화랑대사거리(개선)

개선 사항

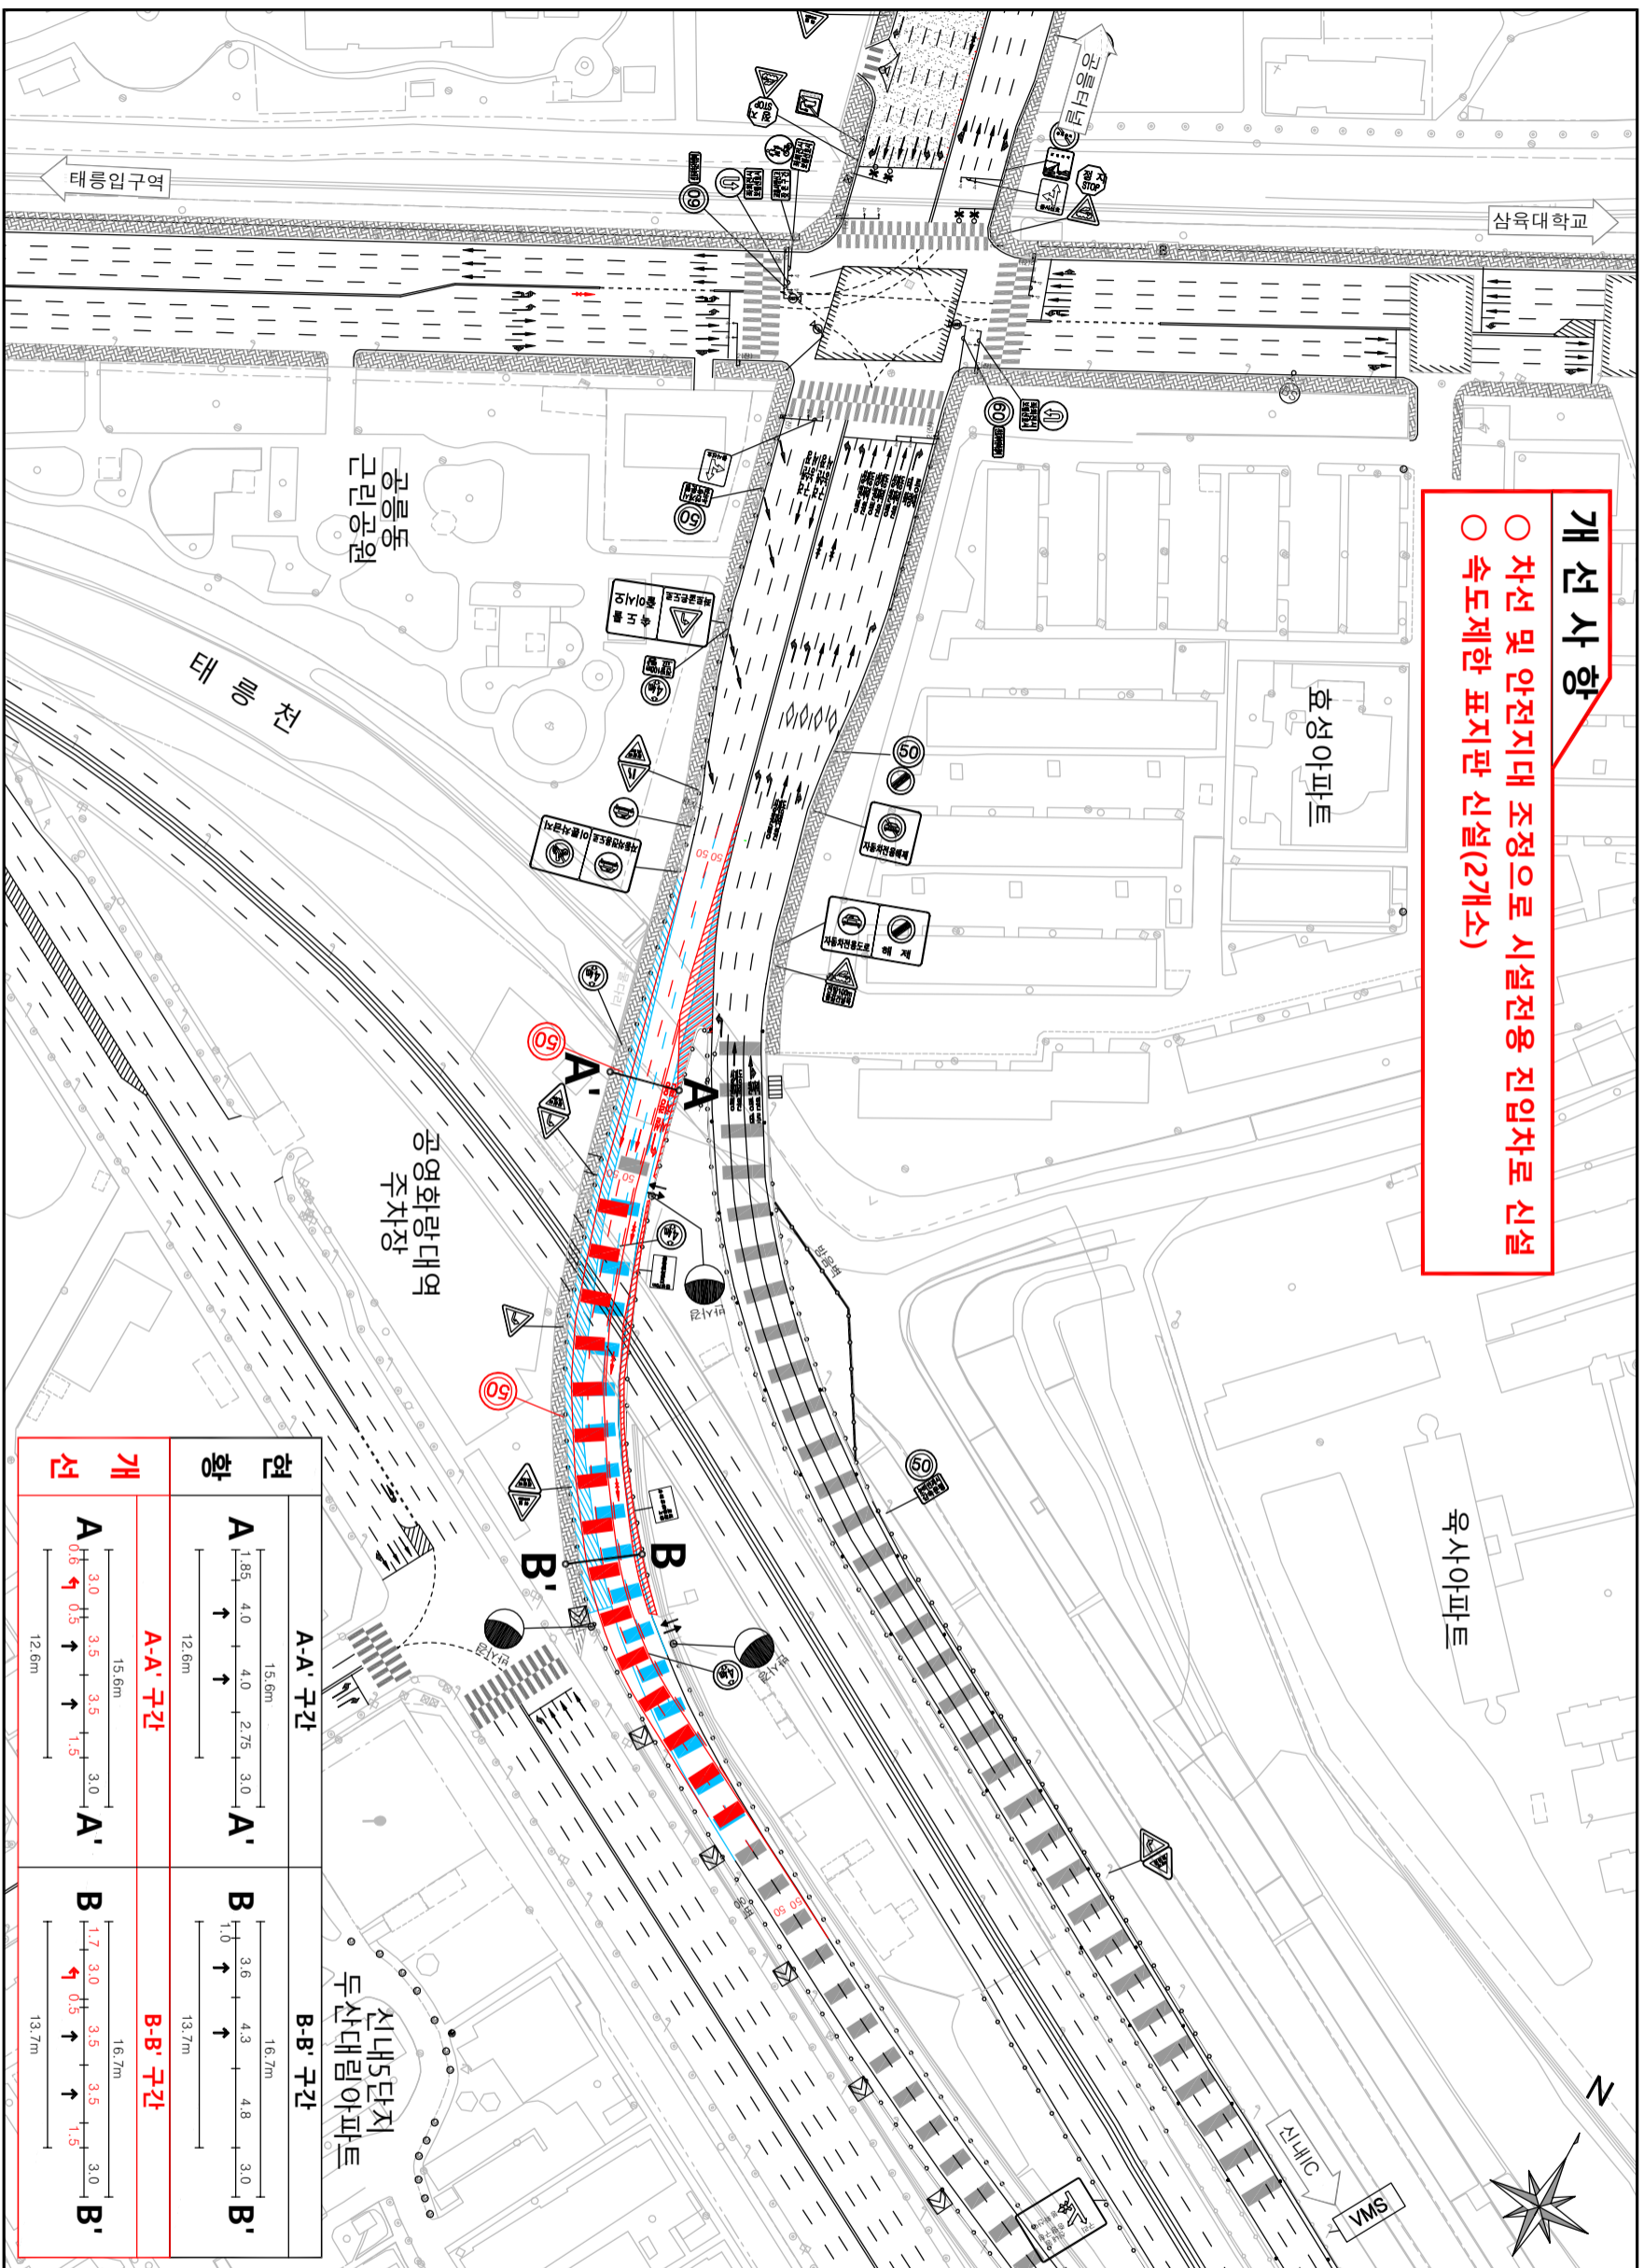
- 차선 및 안전지대 조정으로 시설전용 진입차로 신설
- 속도제한 표지판 신설(2개소)

현황	A-A' 구간	B-B' 구간																																																																						
<b>개선</b>	<table border="1"> <tr> <td>A</td> <td>1.85</td> <td>4.0</td> <td>4.0</td> <td>2.75</td> <td>3.0</td> <td>A'</td> </tr> <tr> <td colspan="7">12.6m</td> </tr> <tr> <td colspan="7"><b>A-A' 구간</b></td> </tr> <tr> <td>A</td> <td>0.8</td> <td>3.0</td> <td>3.5</td> <td>3.5</td> <td>3.0</td> <td>A'</td> </tr> <tr> <td colspan="7">12.6m</td> </tr> </table>	A	1.85	4.0	4.0	2.75	3.0	A'	12.6m							<b>A-A' 구간</b>							A	0.8	3.0	3.5	3.5	3.0	A'	12.6m							<table border="1"> <tr> <td>B</td> <td>1.7</td> <td>3.0</td> <td>3.5</td> <td>3.5</td> <td>3.0</td> <td>B'</td> </tr> <tr> <td colspan="7">13.7m</td> </tr> <tr> <td colspan="7"><b>B-B' 구간</b></td> </tr> <tr> <td>B</td> <td>1.0</td> <td>3.6</td> <td>4.3</td> <td>4.8</td> <td>3.0</td> <td>B'</td> </tr> <tr> <td colspan="7">13.7m</td> </tr> </table>	B	1.7	3.0	3.5	3.5	3.0	B'	13.7m							<b>B-B' 구간</b>							B	1.0	3.6	4.3	4.8	3.0	B'	13.7m
